SERVICE INSTRUCTIONS

No. 0679-395, Rev. II
ATA Code 28-40, 79-30

SUBJECT: INSTRUMENT - SUBPANEL - INSPECTION OF FUEL QUANTITY AND OIL TEMPERATURE INDICATION SYSTEMS

SYNOPSIS OF CHANGE: Added torque note to step 5. Changed oil temperature requirement in step 9.

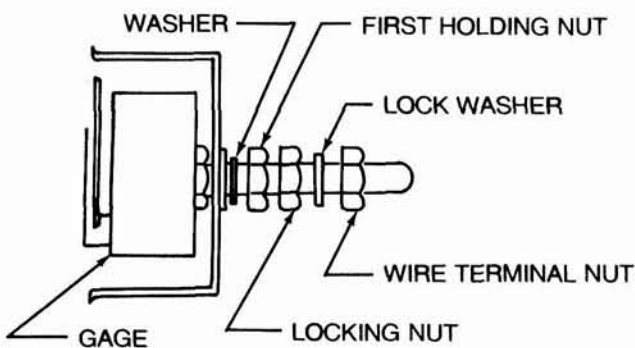
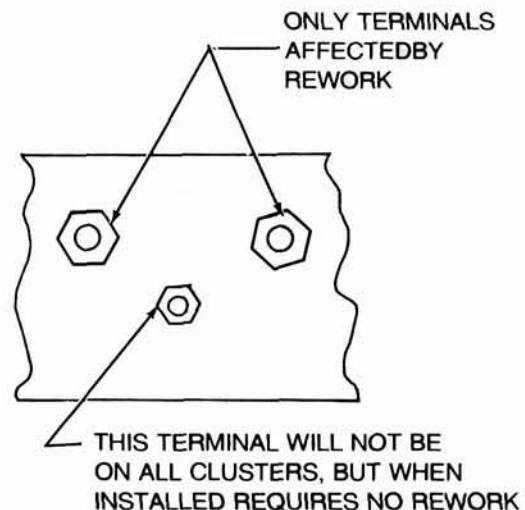
1. Ensure that all electrical power is turned off.
2. Disconnect the electrical wires and loosen all hardware on the two terminals on the back of each fuel quantity and oil temperature gage. (See illustration.)

3. Using a torque wrench, retorque the first holding nut on each terminal to 20/22 inch-pounds. (See illustration.)
4. Hold the first holding nut with a 3/8-inch open end wrench (not to exceed .09-inch thickness) and torque the locking nut on each terminal to 22 inch-pounds. (See illustration.)
5. Reinstall the electrical wires which were removed in step two except to the "Send" terminal of the oil temperature gage. (Do not exceed 20 inch pounds torque on the terminal.)
6. Hold the first holding nut with the 3/8-inch wrench when tightening the nut down on the wire terminal.
